MAYBERRY COMMUNITIES MASTER DEVELOPMENT DRAINAGE PLAN

SKP236

ORIGINAL SUBMITTAL: JULY 2023

APPENDIX D – DRAINAGE MAPS

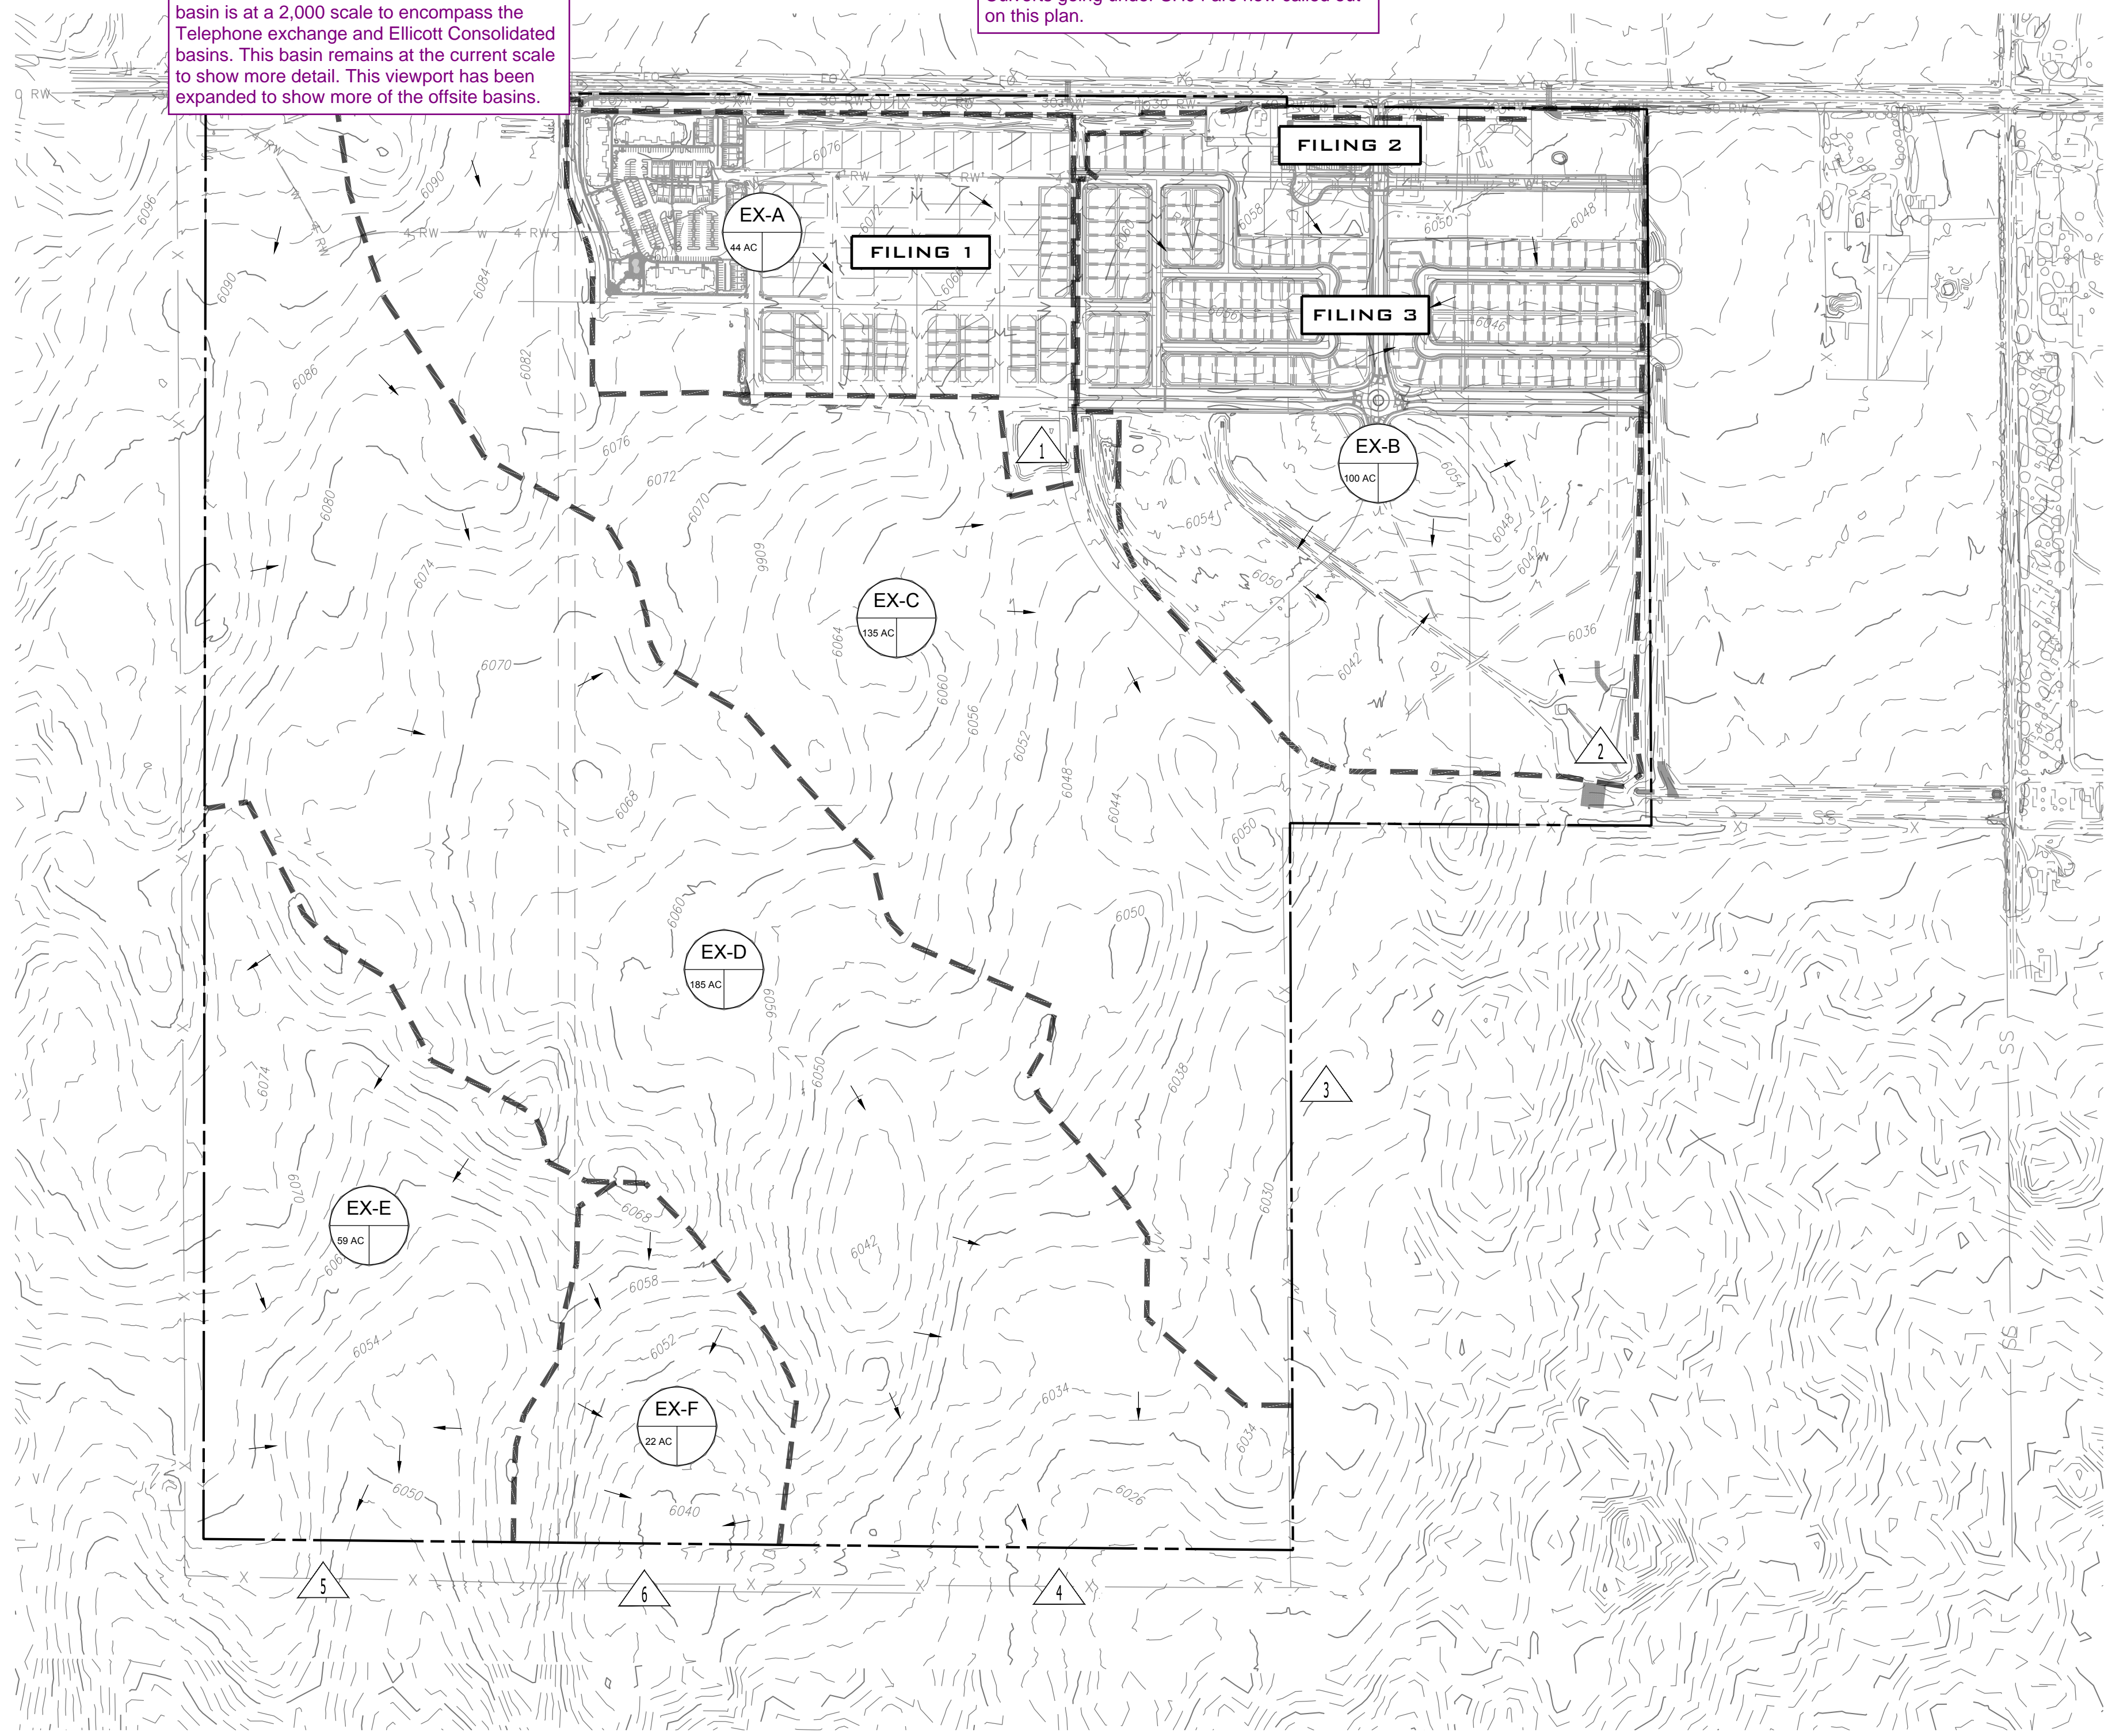
please also show offsite basins with flow arrows on the existing drainage maps

An additional sheet called "Overall Historic Drainage Basin" has been added as DR1 and this sheet is now DR2. The overall historic basin is at a 2,000 scale to encompass the Telephone exchange and Ellicott Consolidated basins. This basin remains at the current scale to show more detail. This viewport has been expanded to show more of the offsite basins.

Culverts going under SH94 are now called out on this plan.

HISTORIC DRAINAGE PLAN

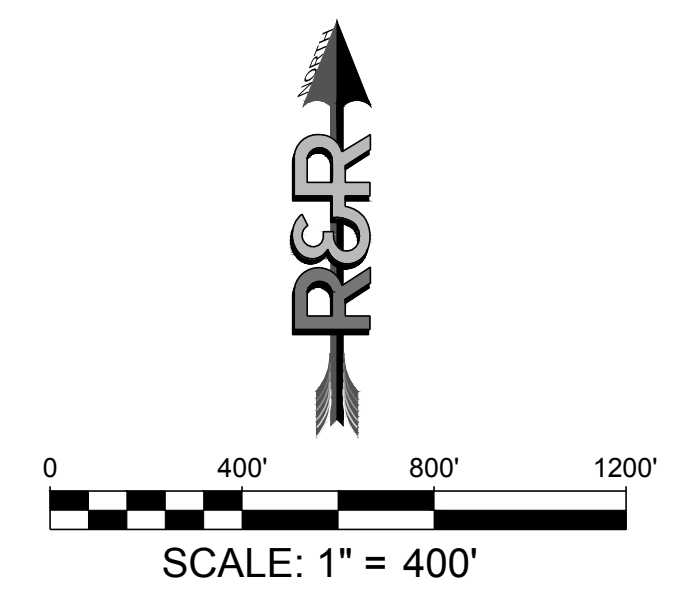
provide a design point summary table with 5 and 100yr flows

label the locations of the existing CMP on the northern boundary conveying off-site flow onto the site and provide design points with runoff values.

Design point summary table has been provided.

The road names have changed in the Sketch plan.
Road names have been updated accordingly.

OVERALL PROPOSED DRAINAGE MAP

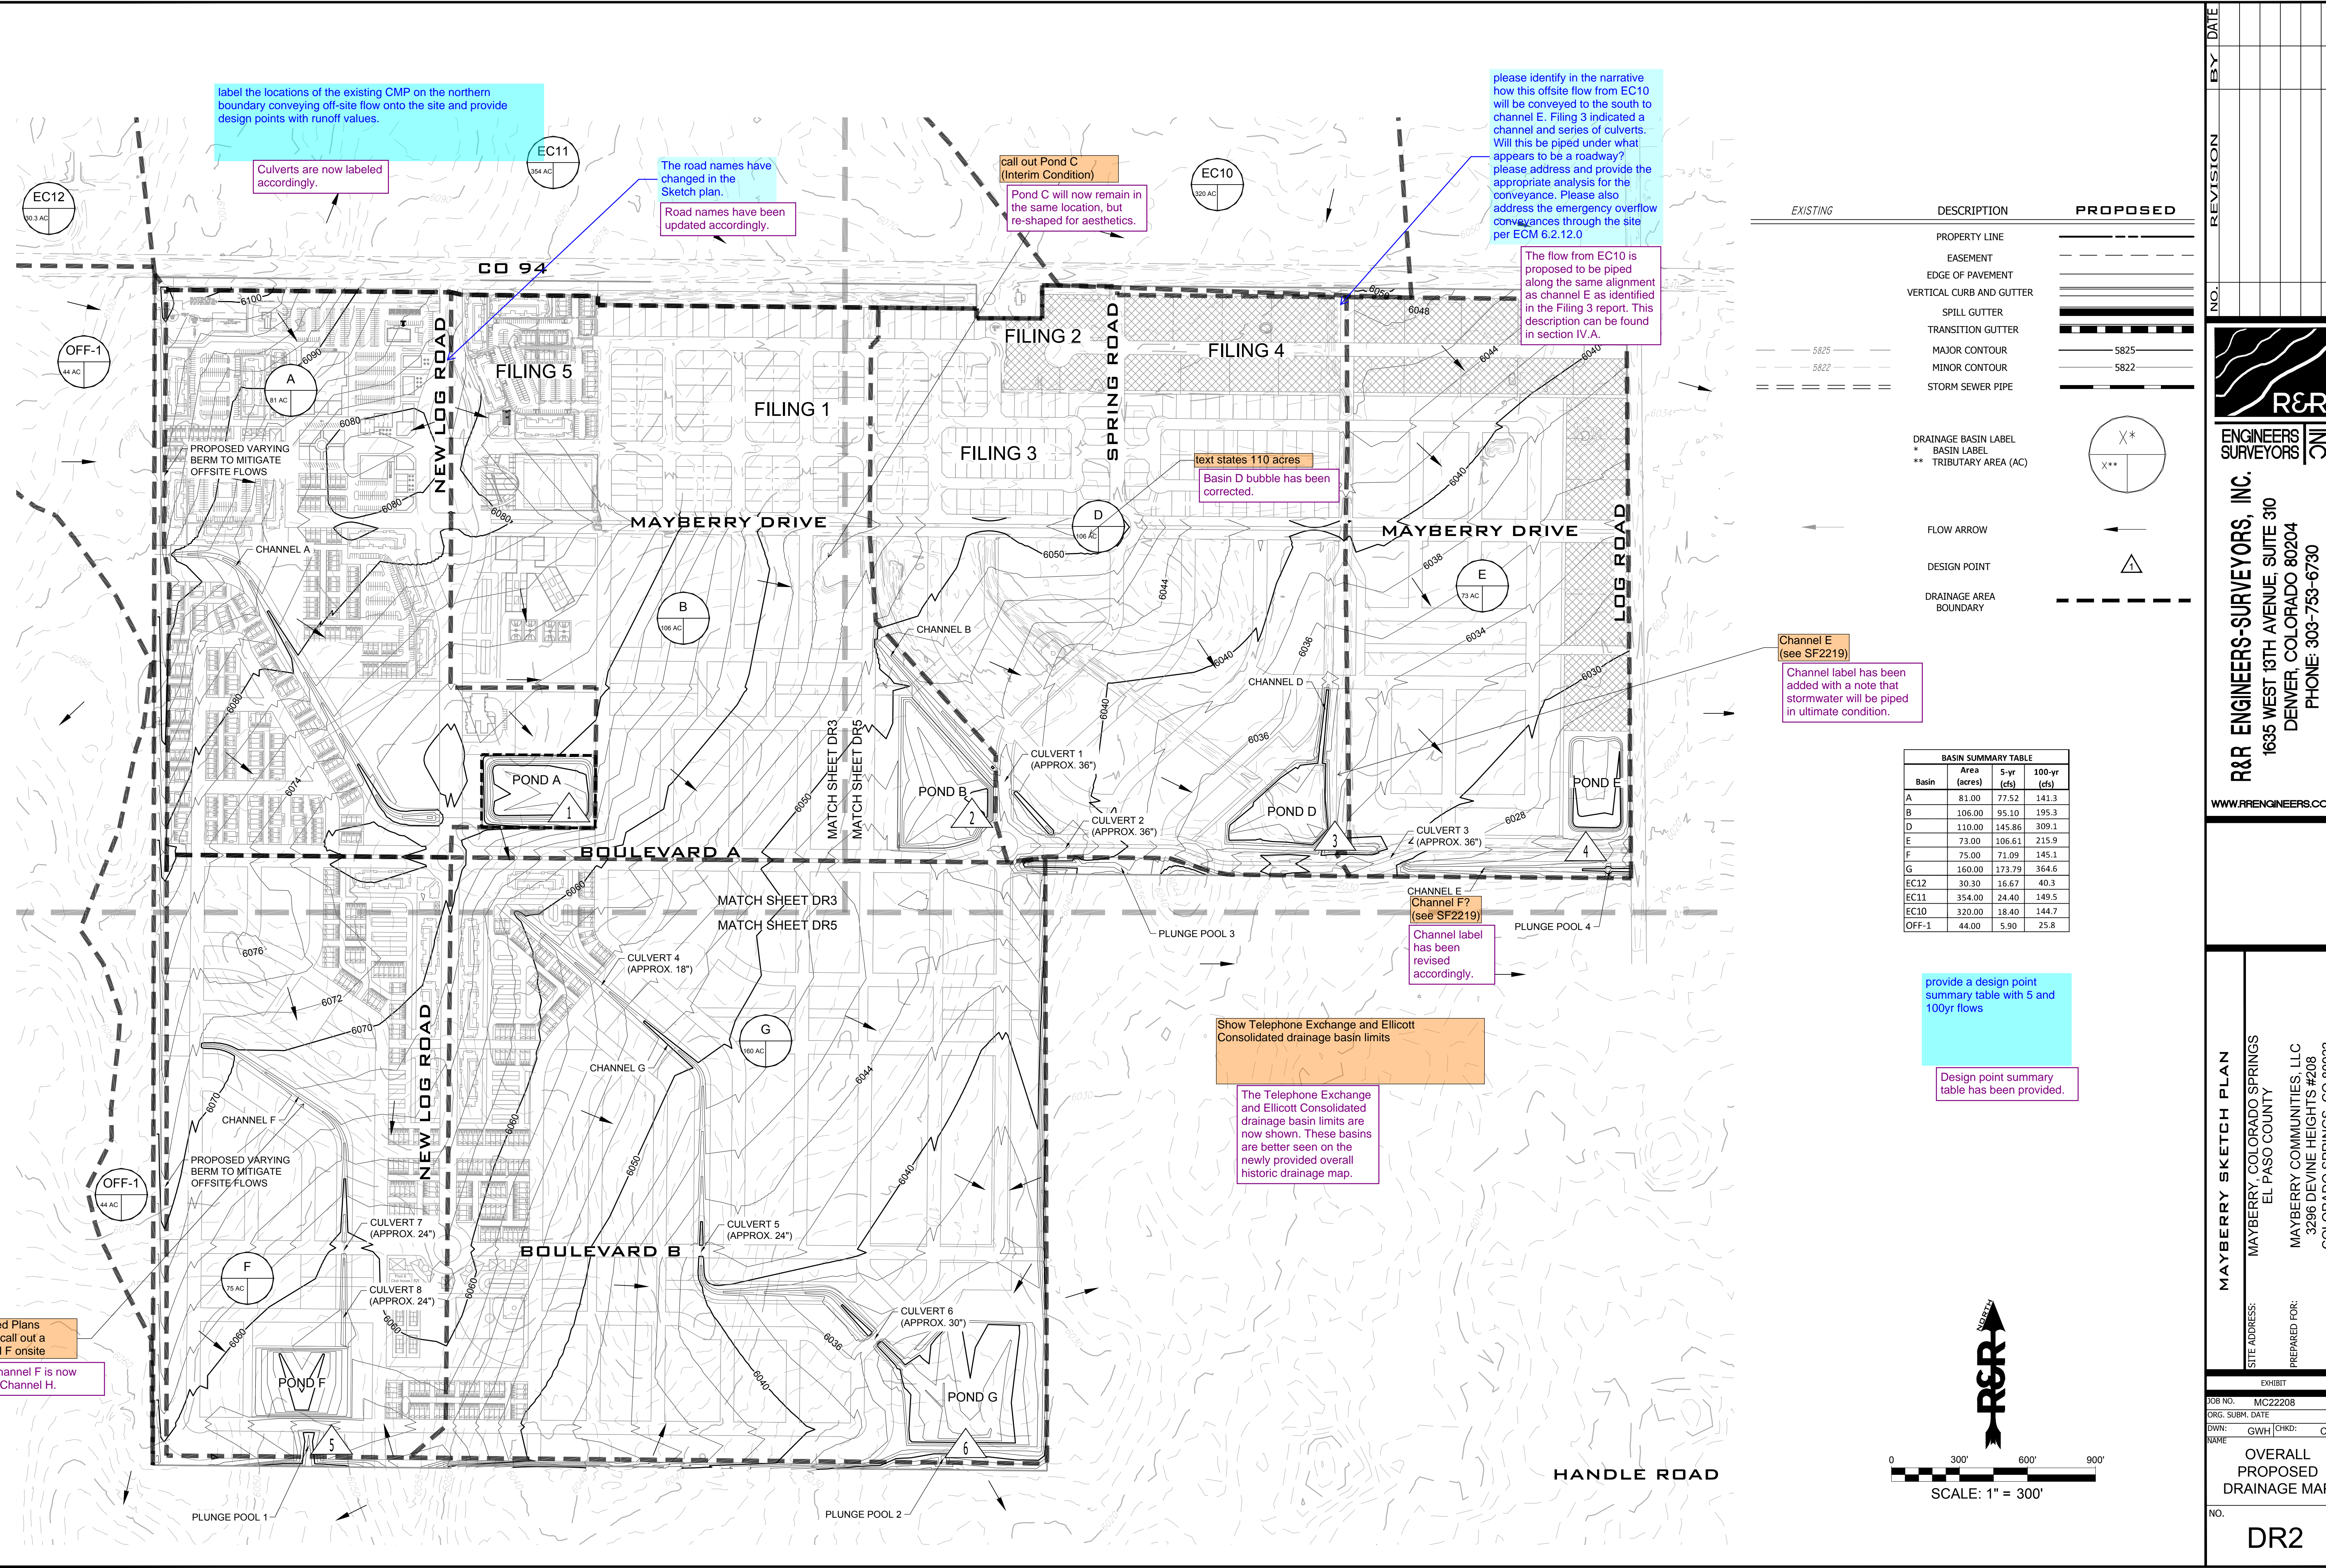
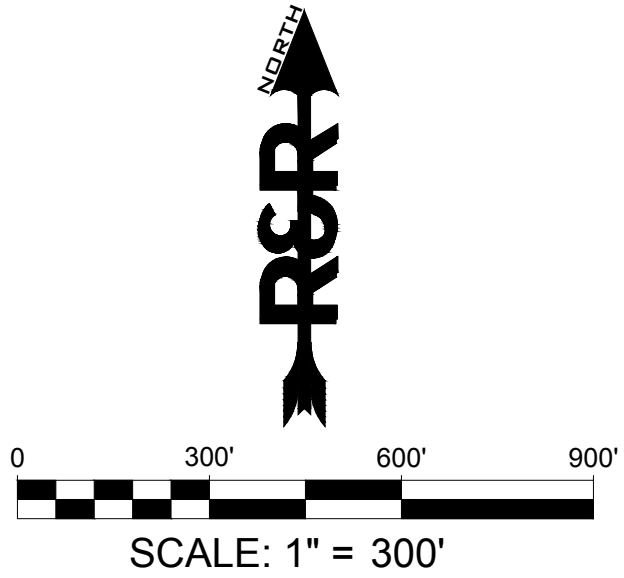
please identify in the narrative how this offsite flow from EC10 will be conveyed to the south to channel E. Filing 3 indicated a channel and series of culverts. Will this be piped under what appears to be a roadway? please address and provide the appropriate analysis for the conveyance. Please also address the emergency overflow conveyances through the site per ECM 6.2.12.0

provide a design point summary table with 5 and 100yr flows

Show Telephone Exchange and Ellicott Consolidated drainage basin limits

Approved Plans already call out a Channel F onsite

Channel E (see SF2219)
Channel label has been added with a note that stormwater will be piped in ultimate condition.

Design point summary table has been provided.
